NRC 2013-0036  
10 CFR 50.90

Point Beach Nuclear Plant, Units 1 and 2  
Dockets 50-266 and 50-301  
Renewed License Nos. DPR-24 and DPR-27

Supplement 2 to License Amendment Request 252  
Technical Specification 5.6.5, Reactor Coolant System (RCS)  
Pressure and Temperature Limits Report (PTLR)

**SUPPLEMENT 2 TO LICENSE AMENDMENT REQUEST 252  
TECHNICAL SPECIFICATION 5.6.5, REACTOR COOLANT SYSTEM (RCS)  
PRESSURE AND TEMPERATURE LIMITS REPORT (PTLR)**

Figure 1  
RCS PRESSURE-TEMPERATURE LIMITS FOR HEATUP

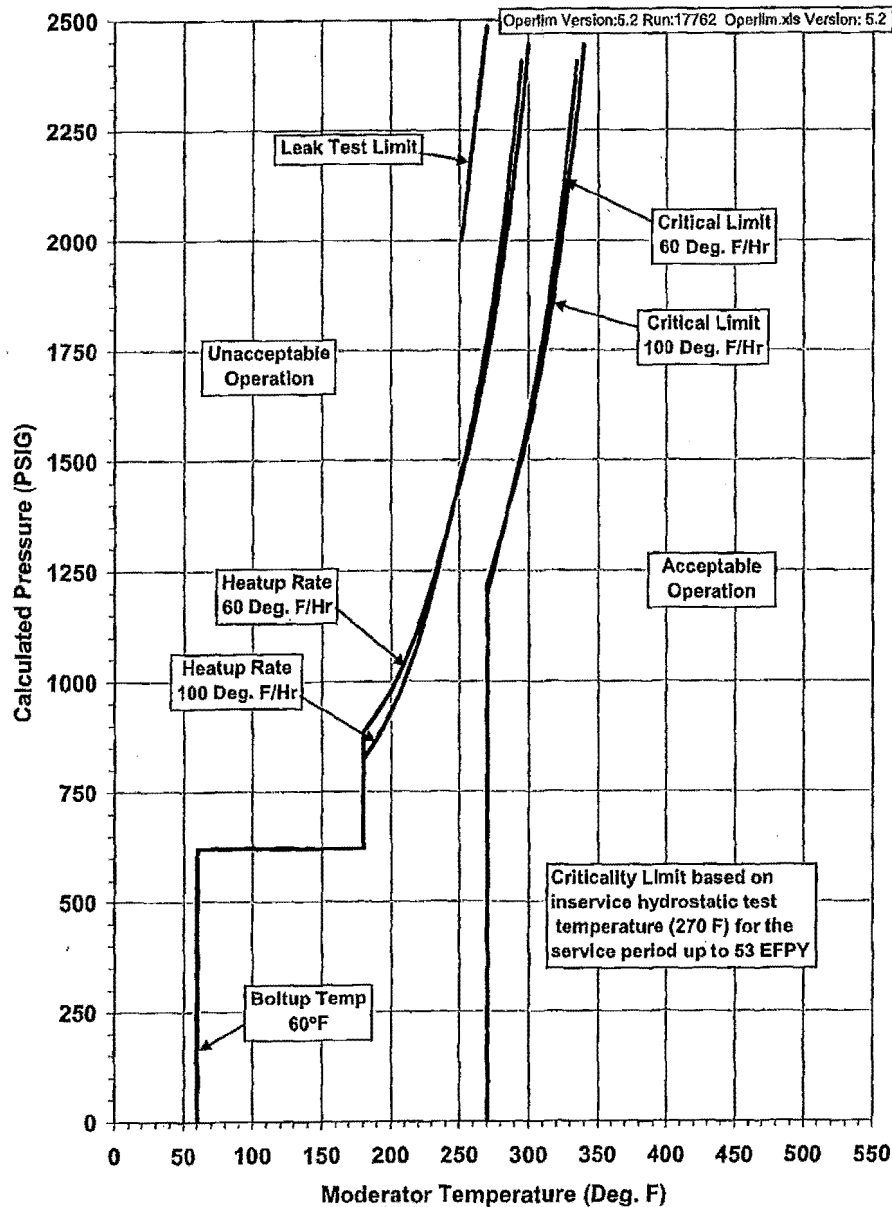
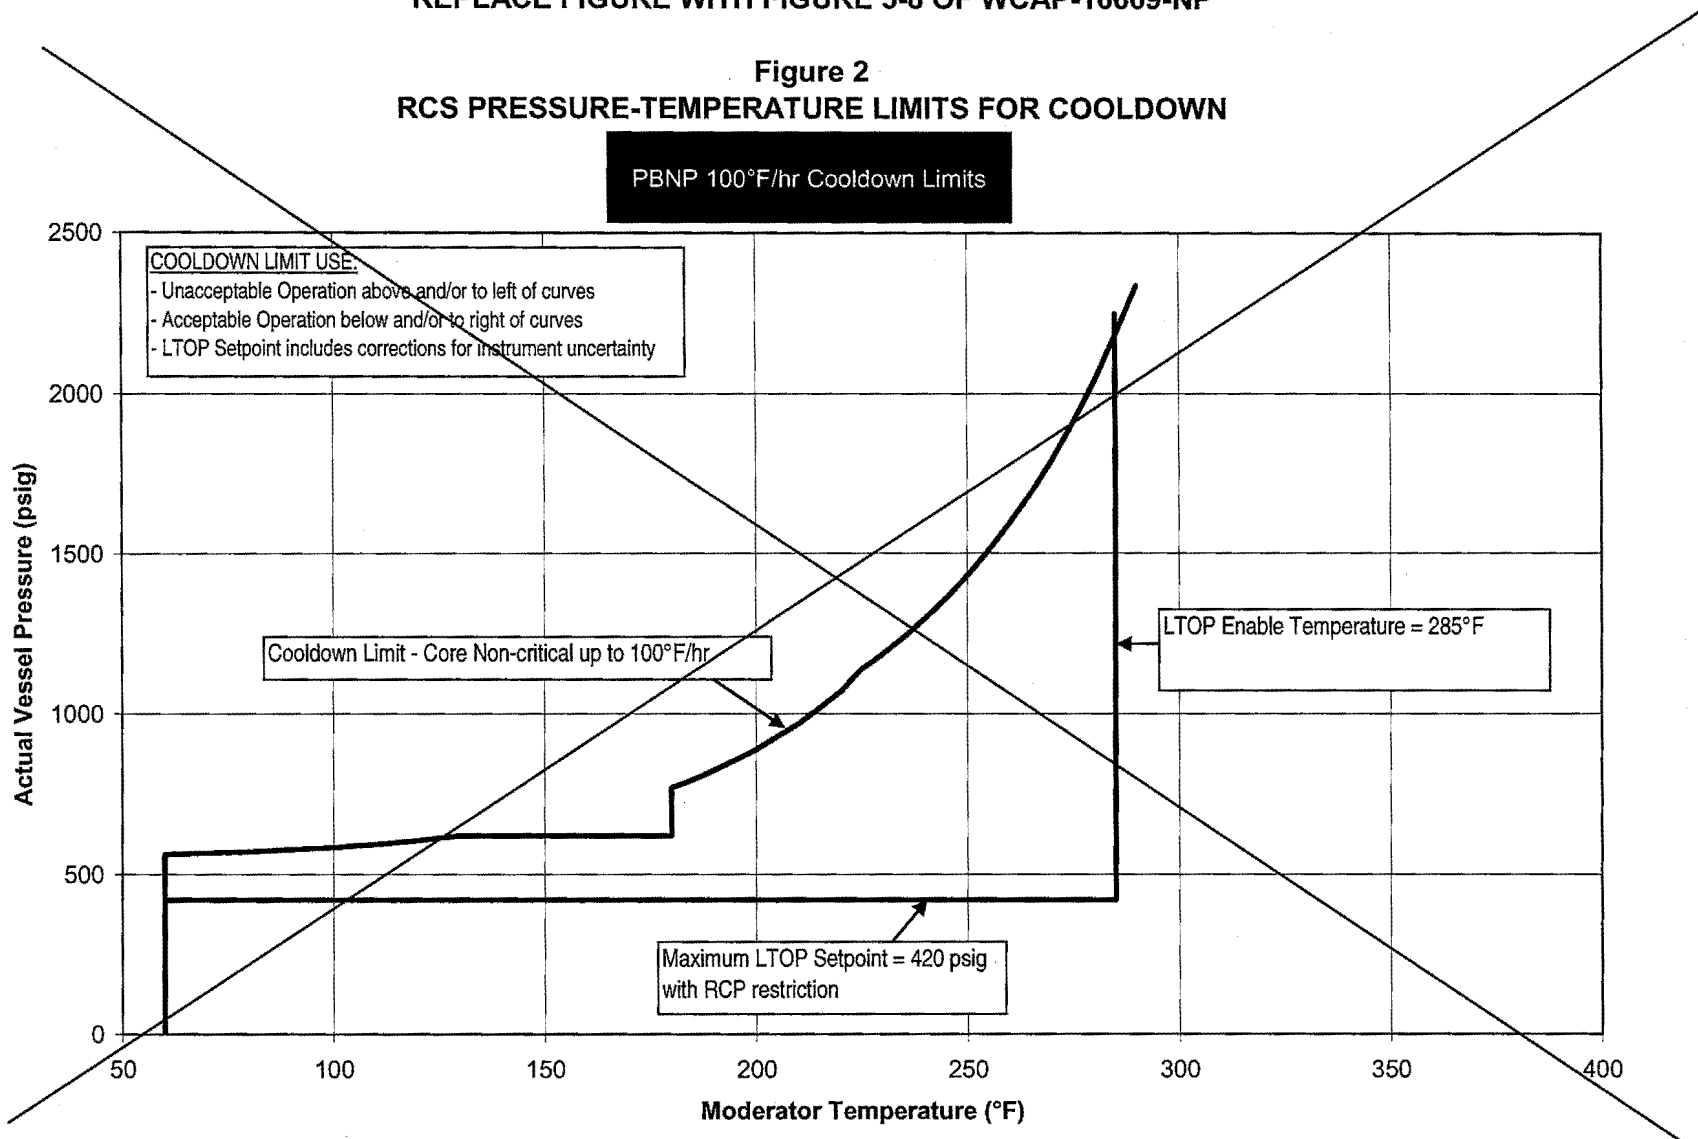
REPLACE FIGURE WITH FIGURE 5-7 OF WCAP-16669-NP

1/4T, 220.0°F

3/4T, 184.6°F

Figure 5-7 Point Beach Units 1 and 2 Reactor Coolant System Heatup Limitations (Heatup Rates of 60 and 100°F/hr) Applicable for 53 EFPY (with Hafnium Removal and without Margins for Instrumentation Errors) Using 1998 App. G Methodology (w/K<sub>ic</sub>)

Figure 2  
RCS PRESSURE-TEMPERATURE LIMITS FOR COOLDOWN

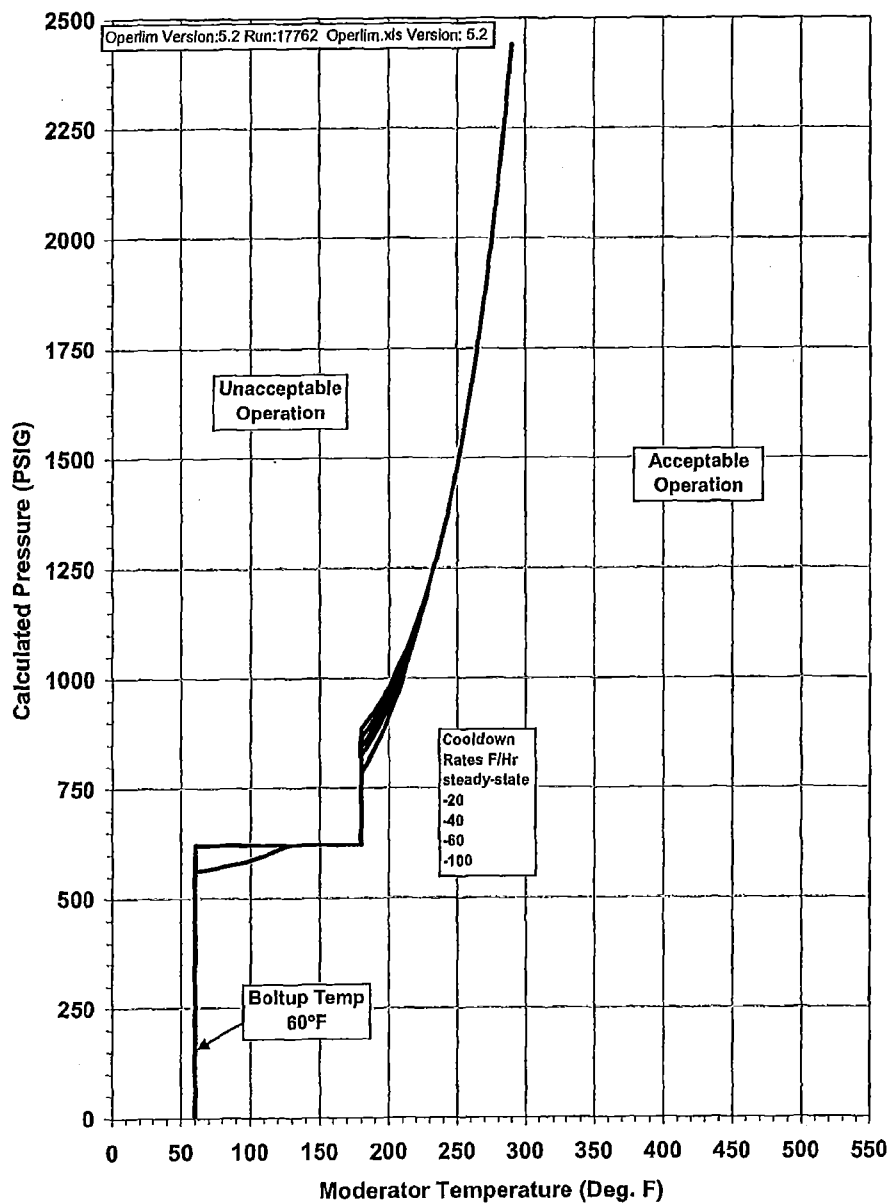
REPLACE FIGURE WITH FIGURE 5-8 OF WCAP-16669-NP

1/4T, 220.0°F

3/4T, 184.6°F

Figure 5-8 Point Beach Units 1 and 2 Reactor Coolant System Cooldown Limitations (Cooldown Rates up to 100°F/hr) Applicable for 53 EFPY (with Hafnium Removal and without Margins for Instrumentation Errors) Using 1998 App. G Methodology (w/K<sub>IC</sub>)
